U. S. Nuclear Regulatory Commission
Attention: Document Control Desk
Washington, D. C. 20555

Serial No. NA3-08-086R
Docket No. 52-017
COL/GY

DOMINION VIRGINIA POWER
NORTH ANNA UNIT 3 COMBINED LICENSE APPLICATION
RESPONSE TO REQUEST FOR ADDITIONAL INFORMATION LETTER 017

Figure 9.2-201 Plant Service Water System Simplified Diagram

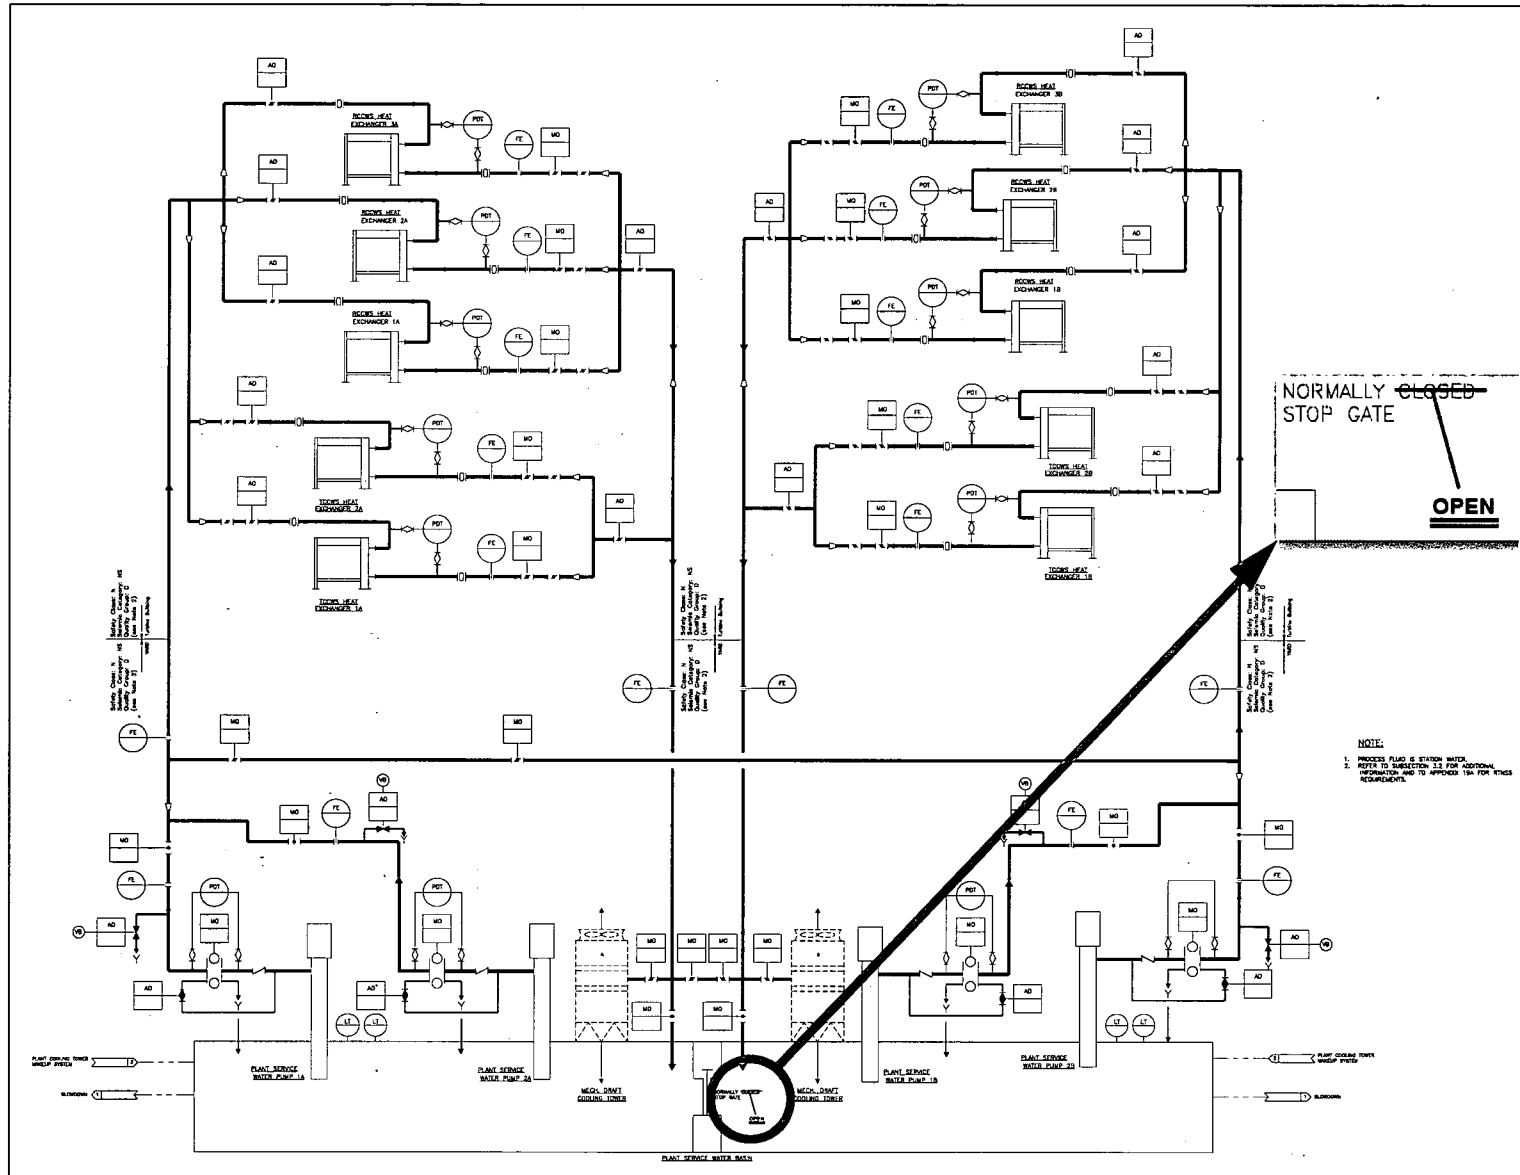
Tier 1 of the ESBWR DCD, Section 4.1, specifies as a COL interface requirement that the plant-specific PSWS be capable of removing 2.02×10^7 MJ (1.92×10^{10} BTU) over a period of seven days without active makeup. The proposed plant-specific ITAAC (Part 10: ITAAC, Table 2.4.2-1) specifies a cooling tower basin water inventory requirement as a way of demonstrating that the heat removal capability specified by the DCD has been satisfied. While water inventory is an important factor that must be addressed by the ITAAC, it does not demonstrate that the cooling towers are capable of dissipating the specified heat load. The capability of cooling towers to dissipate heat is dependent on a number of other factors that should be taken into consideration, such as cooling tower design attributes; the capability to satisfy the PSWS pump minimum net positive suction head (NPSH) requirements for the most limiting cooling tower basin water level, temperature, and flow conditions; the maximum allowed PSWS water supply temperature; and the most limiting meteorological assumptions that pertain to the site for determining: (a) heat dissipation capability, and (b) water inventory requirements. Transient analyses that take these factors into consideration (including margin for expected degradation and operating flexibility) and confirmatory testing are usually necessary in order to adequately demonstrate that cooling tower performance satisfies the specified heat removal requirement. Also, the basis and justification for using the combined cooling tower basin inventory for Trains and B were not explained and justified. Please revise the proposed ITAAC to include consideration of these factors such that the specified cooling tower performance capability is adequately demonstrated for both defense-in-depth and RTNSS functions, and revise the FSAR accordingly to fully describe the plant licensing basis in this regard.

Regarding the use of the combined cooling tower basin inventory from Trains A and B, the stop gate in the cooling tower basin is normally open, allowing the PSW pumps to draw water from the entire basin inventory. Figure 9.2-201 will be revised to indicate that the stop gate in the PSWS cooling tower basin is normally open to assure that the entire basin water inventory is available to meet the specified 2.6×10^6 gallon requirement.

The capability of the PSWS cooling towers is based on the typical design attributes associated with the design of nonsafety-related cooling systems utilizing cooling towers. The minimum heat duty for each tower is 2.98×10^8 BTU/hr and the design uses ambient wet bulb temperature (79 °F), approach temperature (9 °F), and cold water (supply) temperature of 88 °F. The system's normal loads are from the RCCWS and TCCWS and the system is designed as a nonsafety-related system to perform a cooldown assuming a LOPP and single train operation. Initial testing of the system includes performance testing of the cooling towers for conformance with design heat loads and water flows. This information is incorporated by reference from the DCD in FSAR Section 9.2.1, with necessary supplements.

During a postulated event where PSWS functions as a RTNSS Criterion C (Low Regulatory Oversight) System, the normal makeup water to the cooling towers is not qualified as a RTNSS function and is considered to be unavailable. The cooling tower basin must have a sufficient volume of water to allow the tower to perform its cooling function without active makeup. The DCD Tier 1 Interface Requirement and ITAAC specify the heat to be removed over seven days to allow a calculation of the amount of water that is needed to support this cooling function without active makeup. The heat load from the components and systems requiring cooling during the seven days indicated by the interface requirement is much less than the design minimum heat duty of each cooling tower. This reduced load is used to analyze the water loss from the

system due to evaporation and drift. The ITAAC in COLA Part 10, Table 2.4.2-1, assesses the volume above minimum pump submergence and below the minimum normal operating level, ensuring adequate NPSHA for the vertical pumps and sufficient inventory to support PSWS cooling of RCCWS.

Therefore, the ITAAC in COLA Part 10, Table 2.4.2-1 meets the intent of the PSWS interface requirement stated in DCD Tier 1, Section 4.1. This ITAAC, in combination with the design and testing requirements described in the FSAR, adequately demonstrates PSWS performance for both defense-in-depth and RTNSS functions as a Criterion C, Low Regulatory Oversight, Maintenance Rule support system.

FSAR Figure 9.2-201 will be revised as indicated in the attached markup.
